JORDAN VALLEY WATER CONSERVANCY DISTRICT

11800 South Pump Station Capacity Upgrade

**ADDENDUM NO. 1
June 11, 2021**

MAIN FLOOR HVAC PLAN
ADDENDUM #1

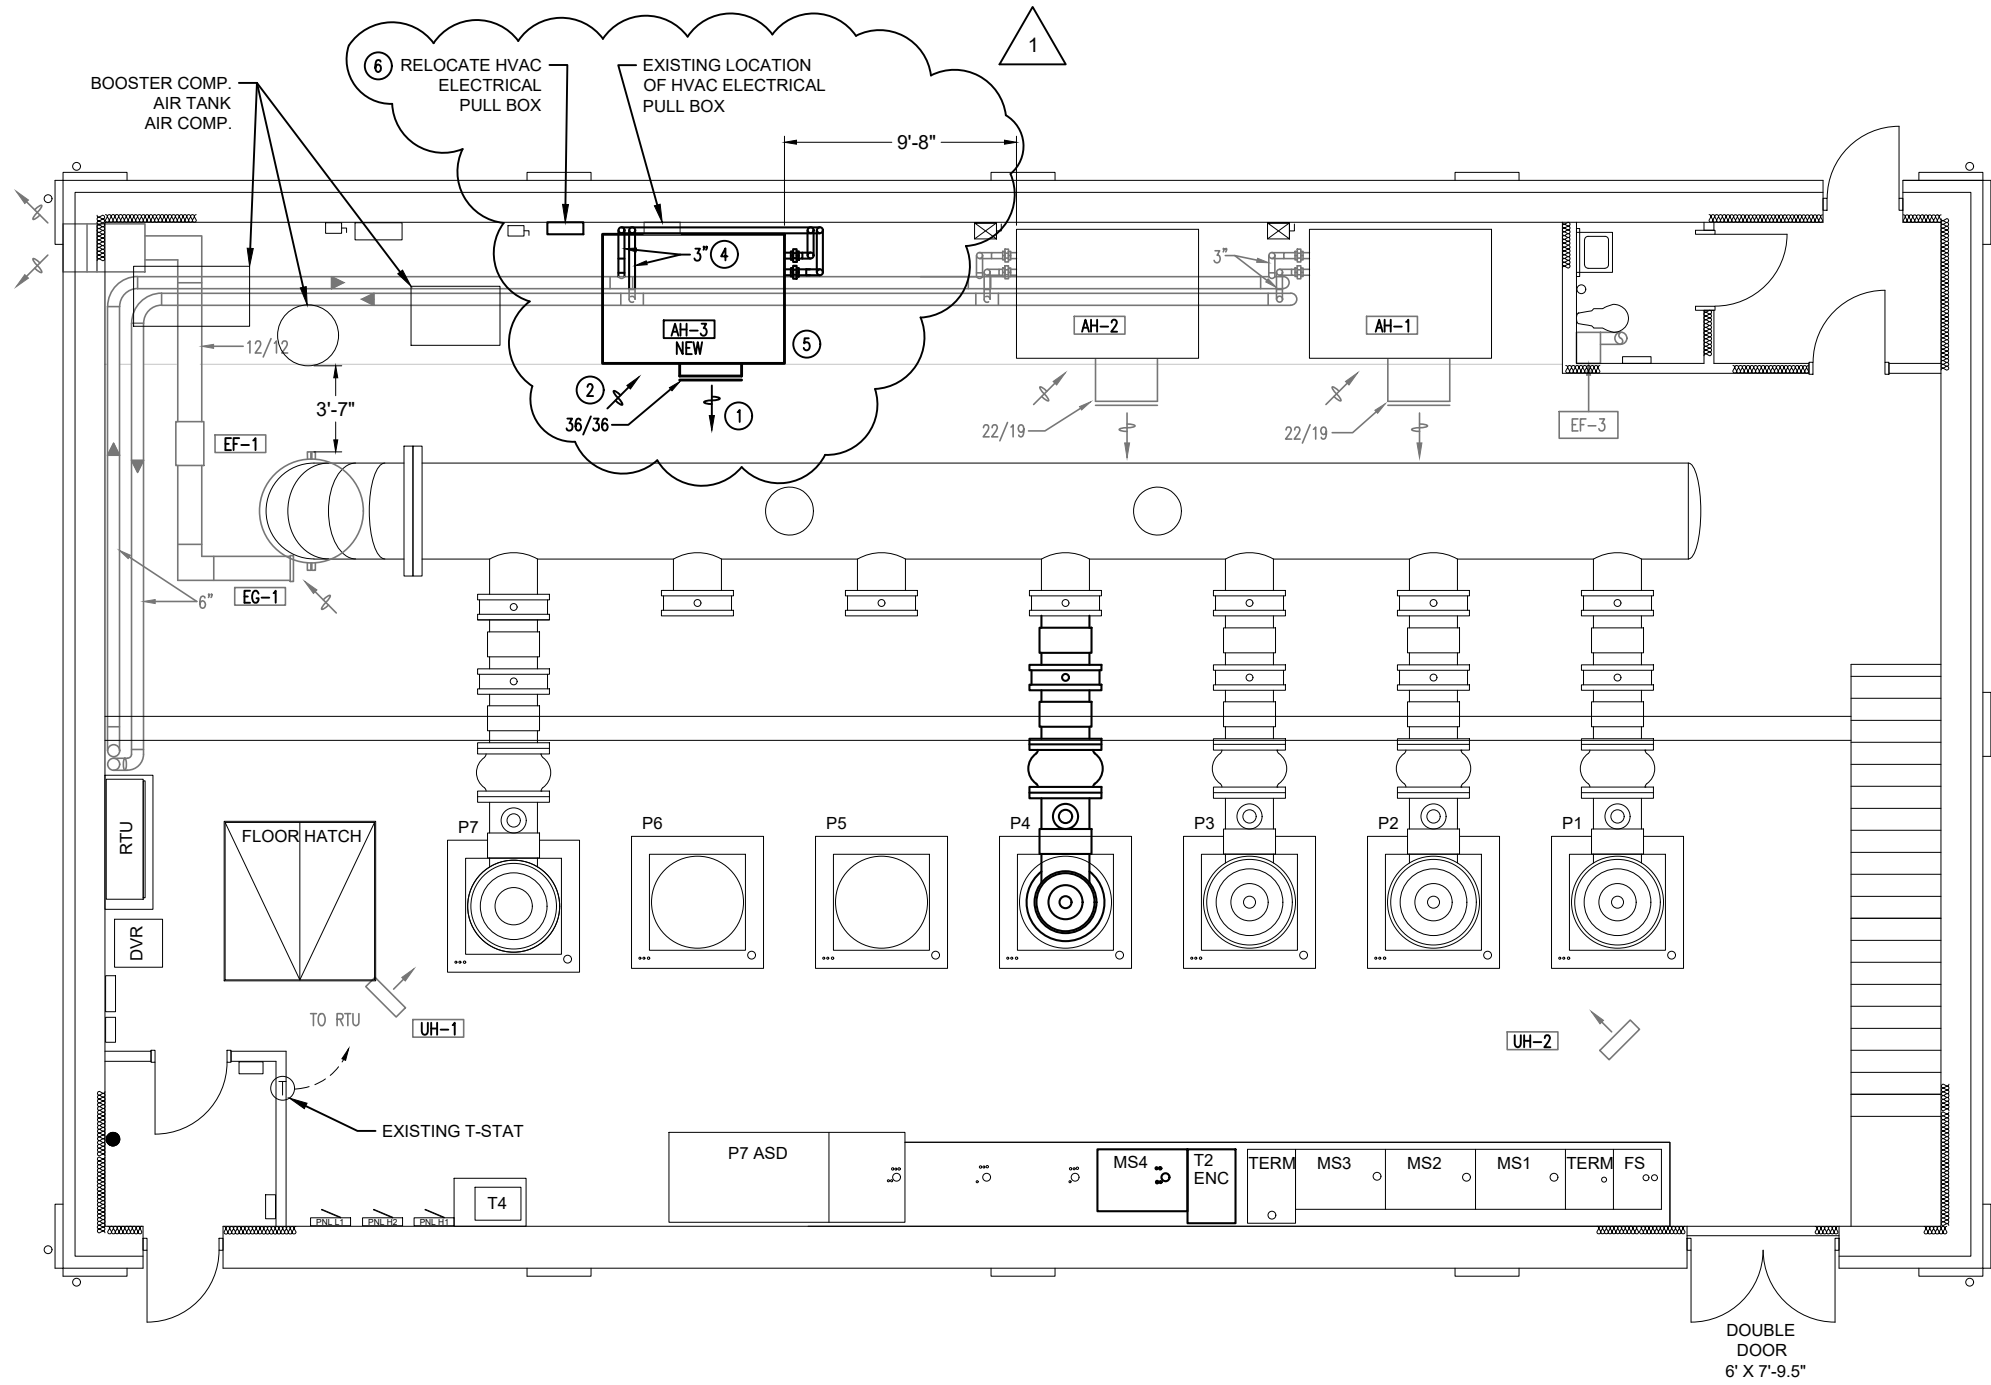
8	Section 44 42 56-5	<p>Modify Paragraph 2.01.L to read as follows:</p> <p>Manufacturer: American-Marsh, Floway, Flowserve, National, Peerless, or approved equal.</p>
9	Section 44 42 56-5	<p>Modify Paragraph 2.03.A to read as follows:</p> <p>Provide one set of mechanical seals for the pump.</p>
10	Drawings MH-1 MH-2 MH-3 MH-4	<p>Replace drawings MH-1, MH-2, MH-3, and MH-4 with the attached drawings. Various revisions were made and are identified with a revision cloud.</p>
